BRIDGELAND

PARKLAND VILLAGE - SECTION 26

FENCE LAYOUT

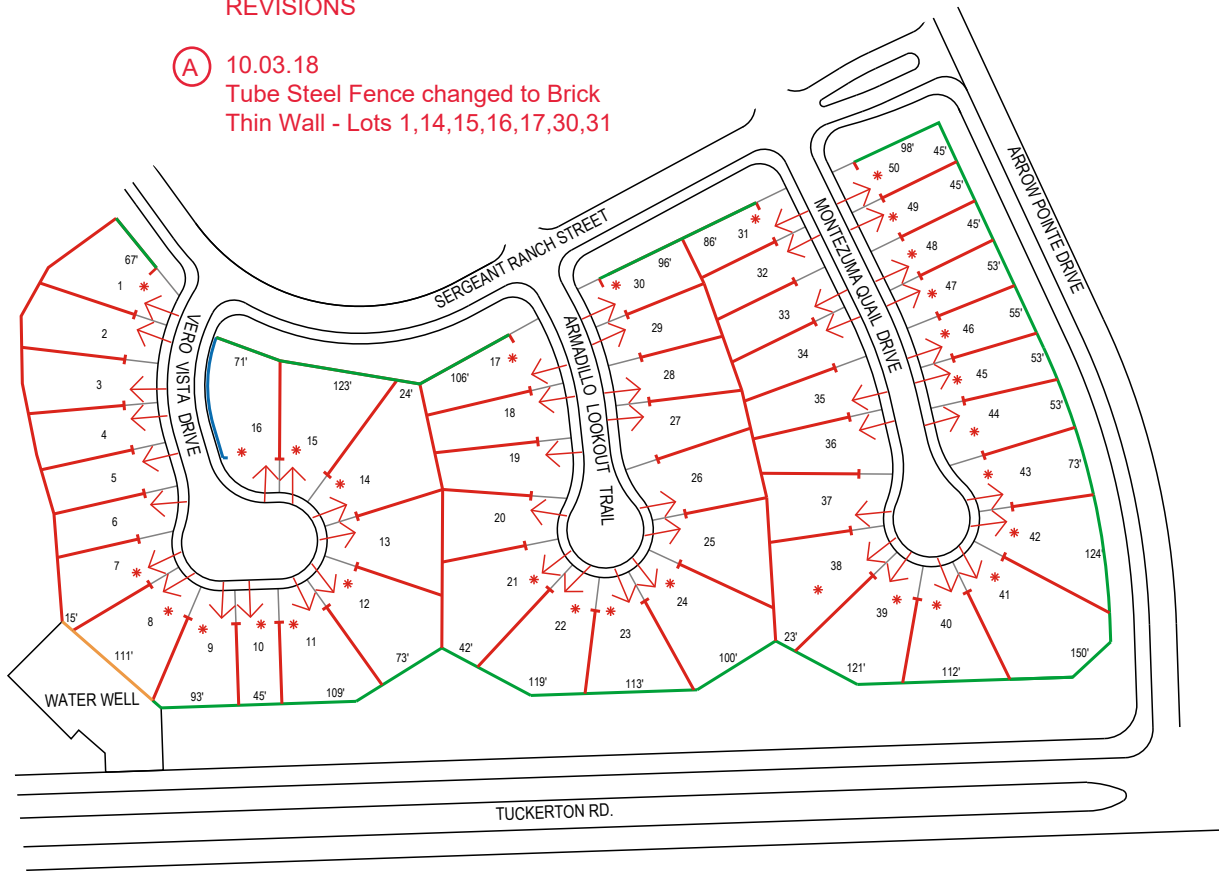
- (A) 10.03.18
 Tube Steel Fence changed to Brick
 Thin Wall - Lots 1,14,15,16,17,30,31
